PROJECT: DMPS Brody-Goodrell-Stowe HVAC Upgrades

DATE: January 12, 2022

NOTE { *THIS ADDENDUM HAS BEEN ISSUED TO MODIFY AND/OR INTERPRET THE BIDDING DOCUMENTS, INCLUDING THE DRAWINGS AND SPECIFICATIONS. UNLESS OTHERWISE INSTRUCTED, THE INFORMATION CONTAINED ON THE ADDENDUM SHALL TAKE PRECEDENCE OVER ANYTHING CONTRARY ON THE ORIGINAL BIDDING DOCUMENTS AND SHALL BE HEREINAFTER CONSIDERED AS A PARTY OF THE BIDDING DOCUMENTS.*

SHEET M2.0N-R1

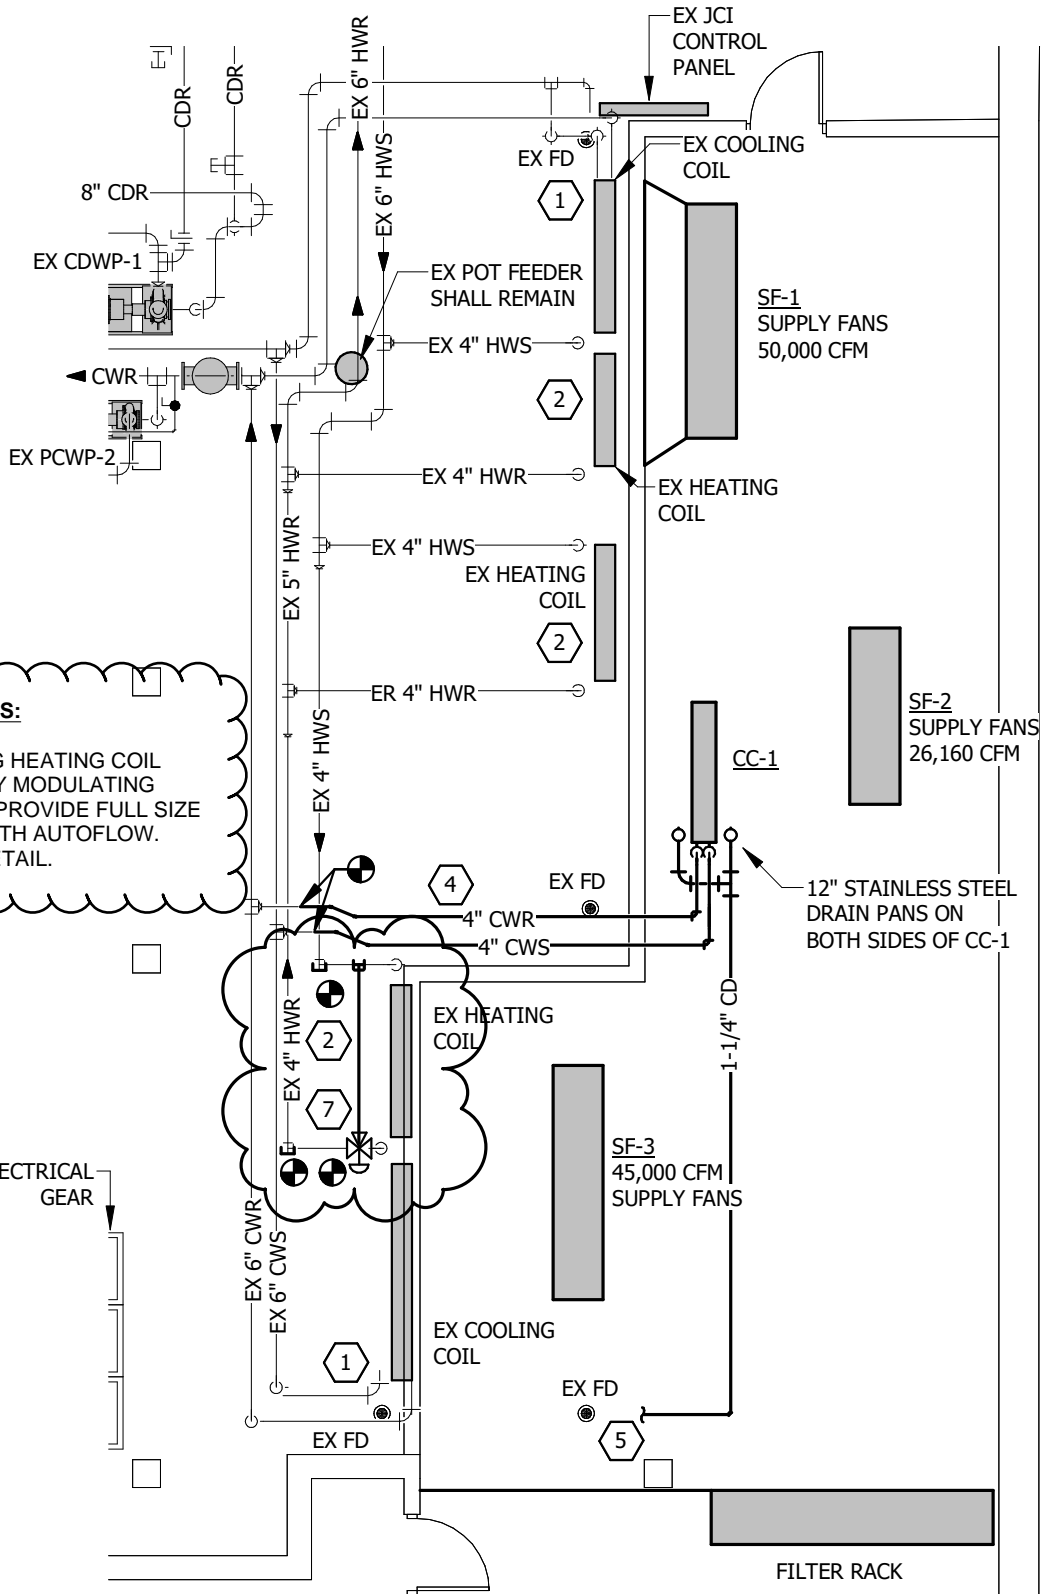
- 1. Basement Equipment Room
 - A. **REVISE** Heating Water piping at Heating Coil on system SF-3 to be a 3-way control valve configuration.

7. REPIPE EXISTING HEATING COIL WITH A NEW 3-WAY MODULATING CONTROL VALVE. PROVIDE FULL SIZE BYPASS PIPING WITH AUTOFLOW. REFER TO COIL DETAIL.

SHEET: M4.1-R1

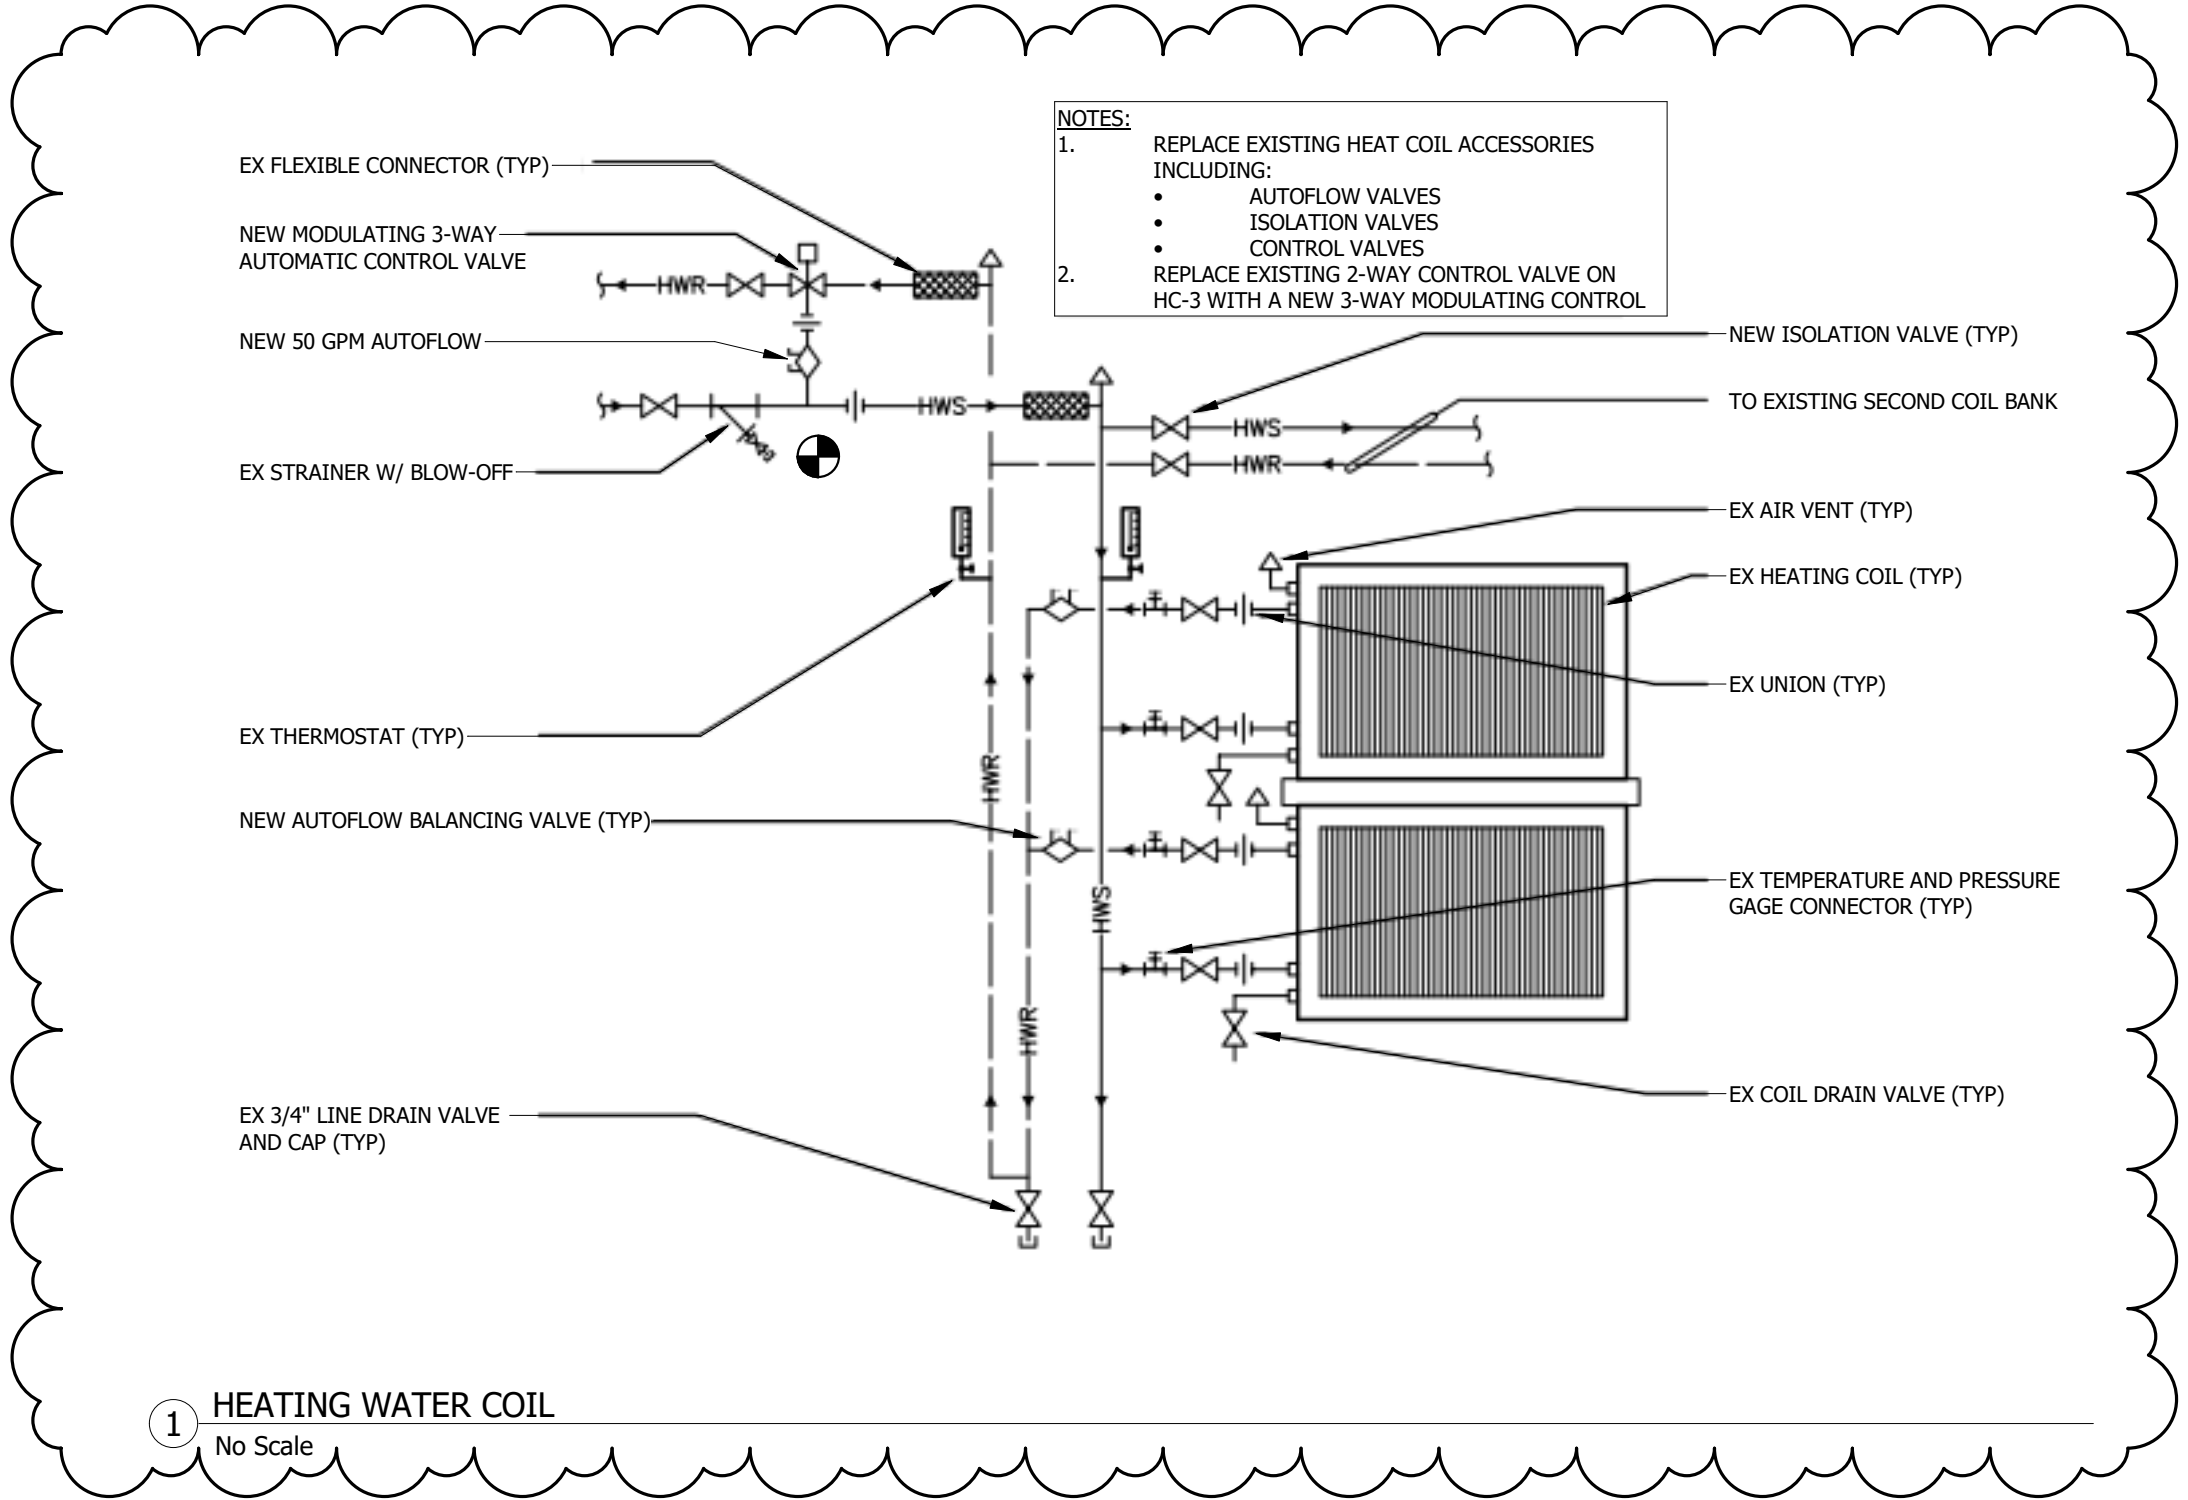
- 1. **ADD** 3-way Heating Coil Detail per attached drawing M4.1-R1.
